# 1733-37 Fairfield Road

Letter to Mayor and Council

# RE: 1733-37 Fairfield Road

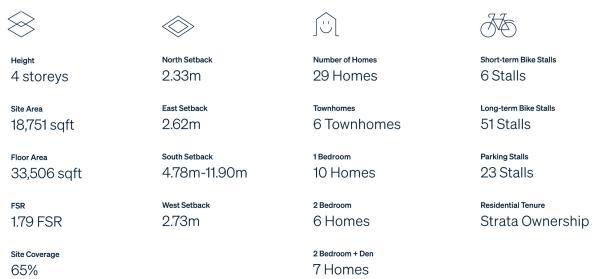
In our ongoing efforts to refine and optimize the project, we are proposing a change to the material on parts of the building exterior. We are proposing to replace the brick with Ceraclad, a high performing fiber cement cladding product. This choice is meticulously considered, ensuring compliance with the Design Guidelines which advocate for the use of high-quality, durable materials to preserve the condition of facades. The coated cement panel (such as the Ceraclad product) will complement the metal panel and still maintain the design approach of how the townhouse units and overall 'base' of the building have

a more substantial and solid expression. One feature also worth noting with the Ceraclad product is that the triple coated membrane will block UV light and rain to reduce deterioration over time. This aligns with the *Guidelines* request for durable materials.
